COPPER GATE NORTH ADDITION

RE: SUB 2004-13 -- Final Plat of Copper Gate North Addition

STAFF REPORT

CASE NUMBER: SUB 2004-13 -- COPPER GATE NORTH ADDITION

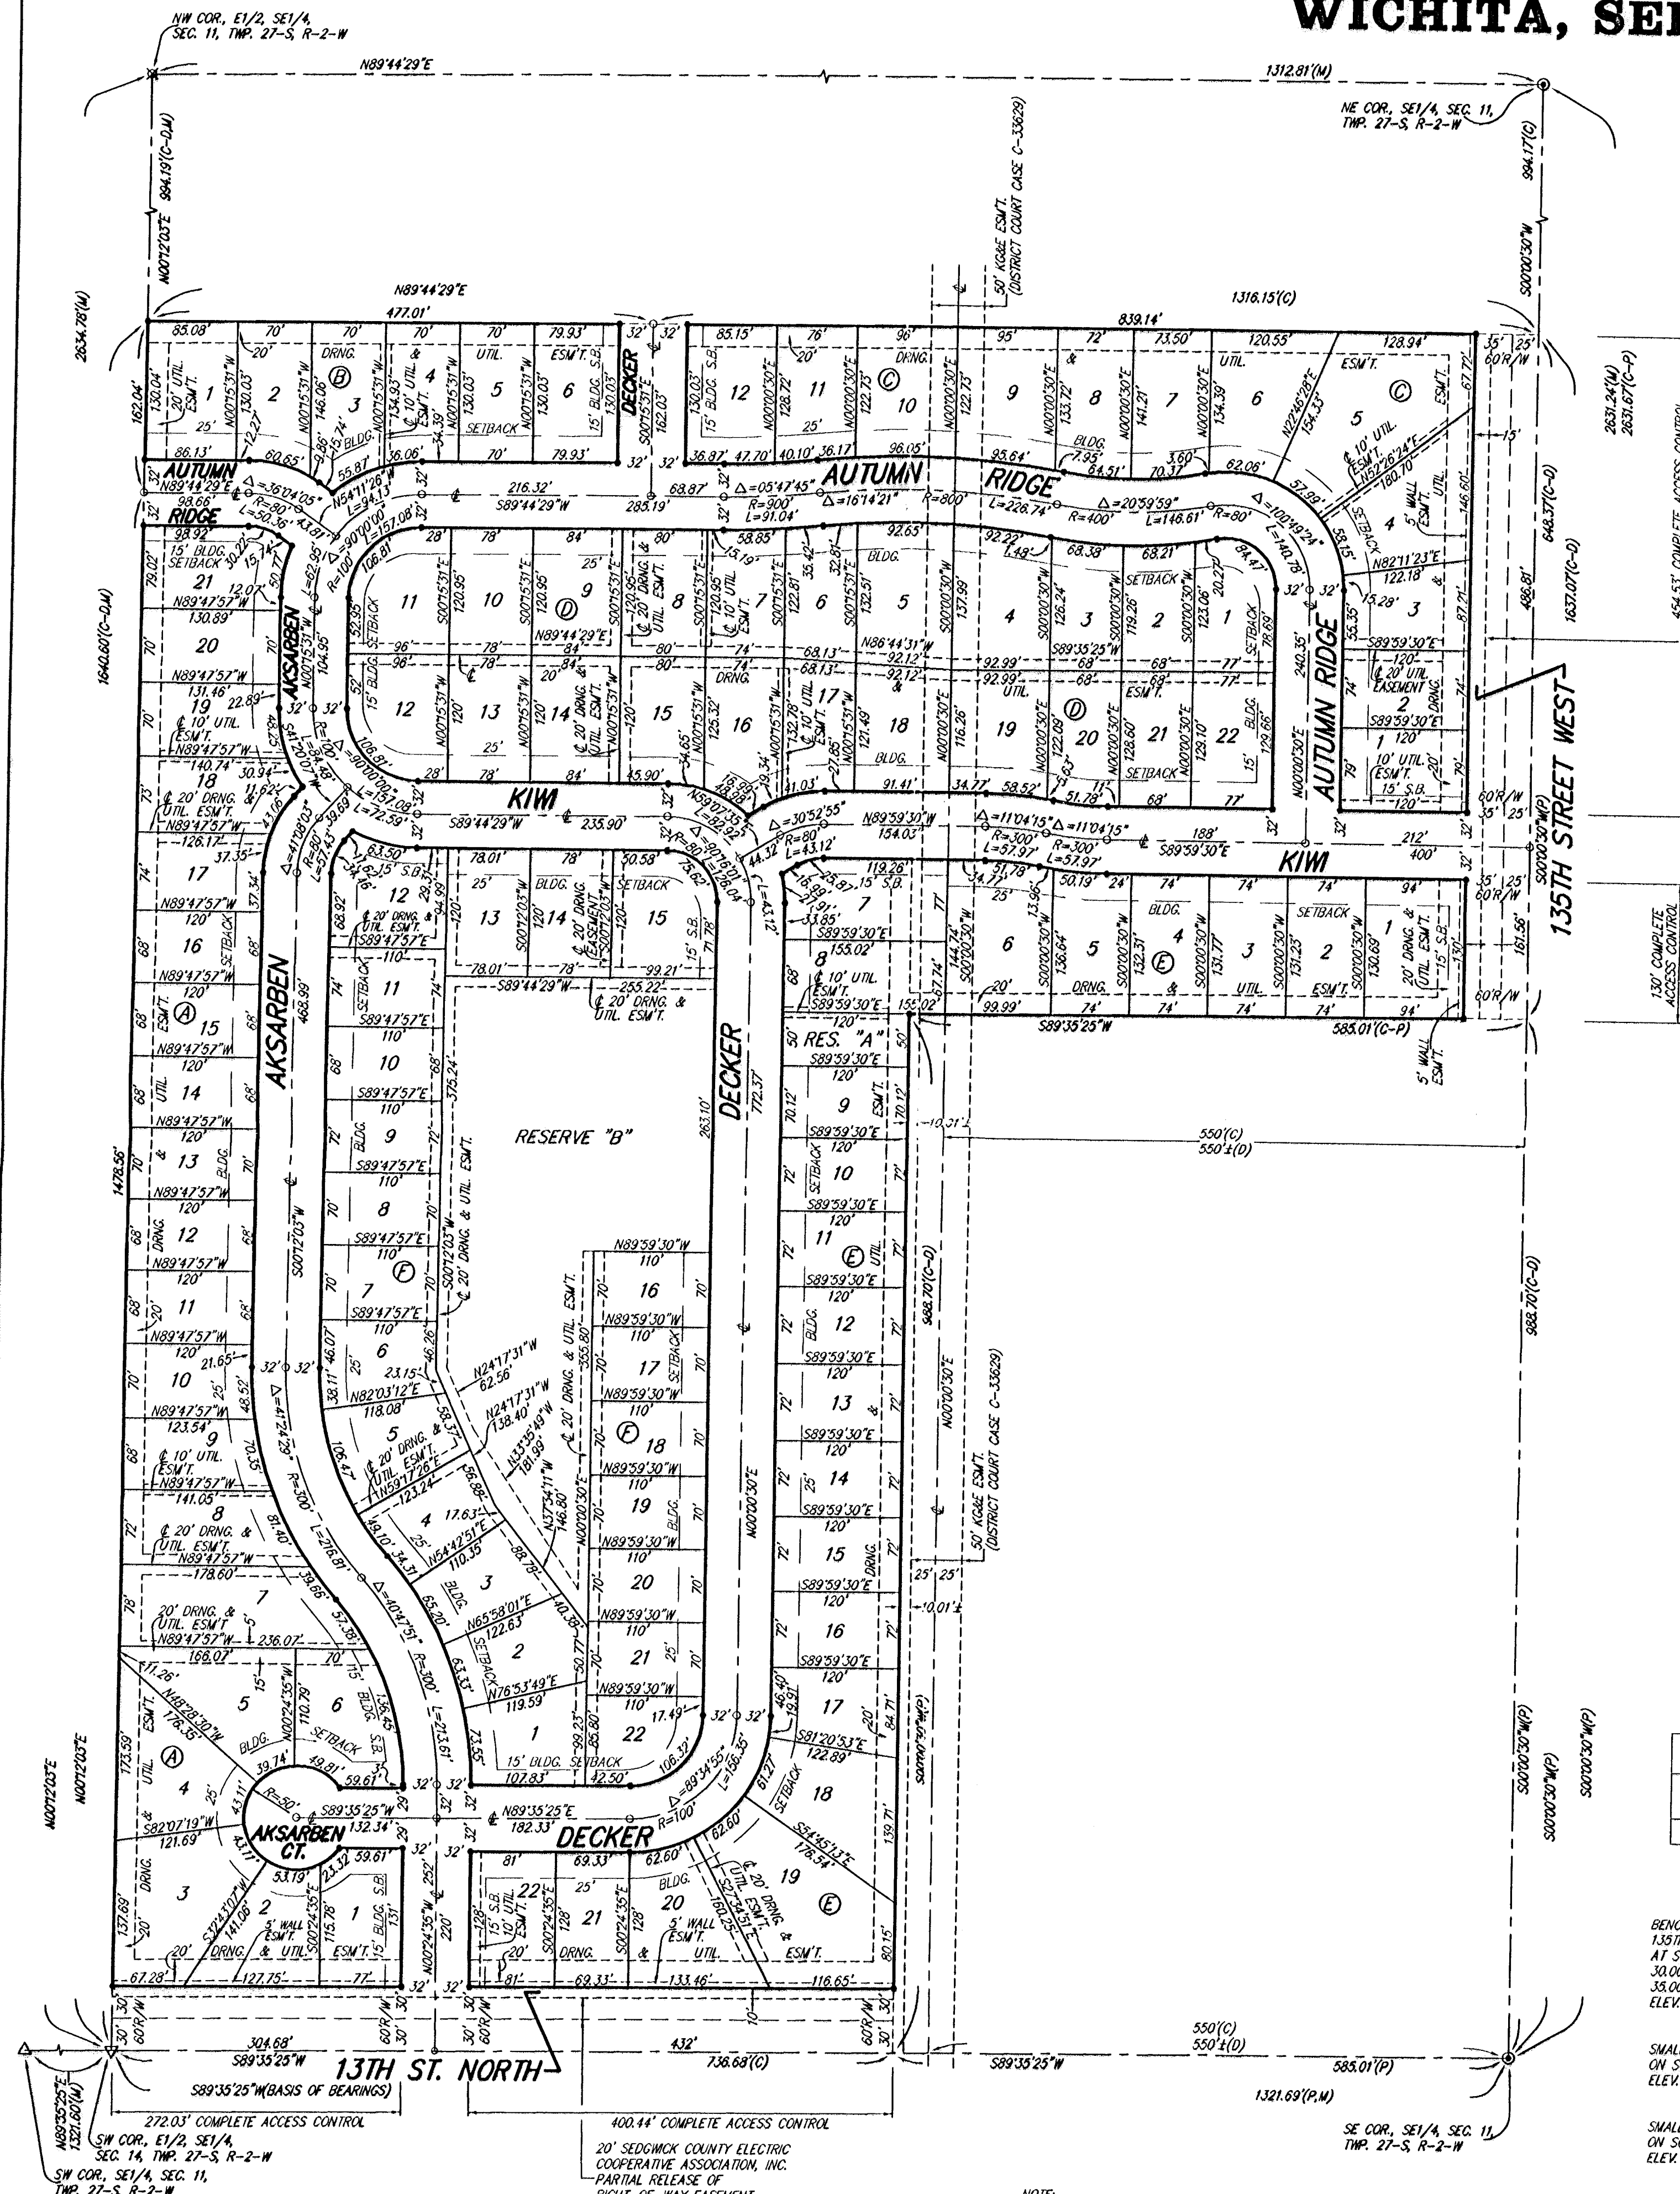
- E. City Engineering has approved the drainage plan. A drainage guarantee is needed. The off-site drainage easement by separate instrument as denoted on the plat needs to be provided to MAPD.

- K. GIS needs to comment on the plat's street names. Old Wick Rd needs to be replaced with a new name. Decker Drive needs to be "Decker". The stub to the west should be labeled as Autumn Ridge.

- L. The plat's text shall include language that a drainage plan has been developed for the plat and that all drainage easements, rights-of-way, or reserves shall remain at established grades or as modified with the approval of the applicable City or County Engineer, and unobstructed to allow for the conveyance of stormwater.

- T. The representatives from the utility companies should be prepared to comment on the need for any additional utility easements to be platted on this property. **Sedgwick County Rural Electric Cooperative will be requesting additional easements. SBC has requested additional easements.**

NOTE:
A master grading plan for drainage has been developed for this subdivision
and is on file with the City of Wichita, Kansas. All drainage easements,
right-of-ways, or reserves shall remain of established grades or as
modified with the approval of the City Engineer of the City of Wichita,
Kansas. No obstructions which impede the flow of this drainage system be
allowed.
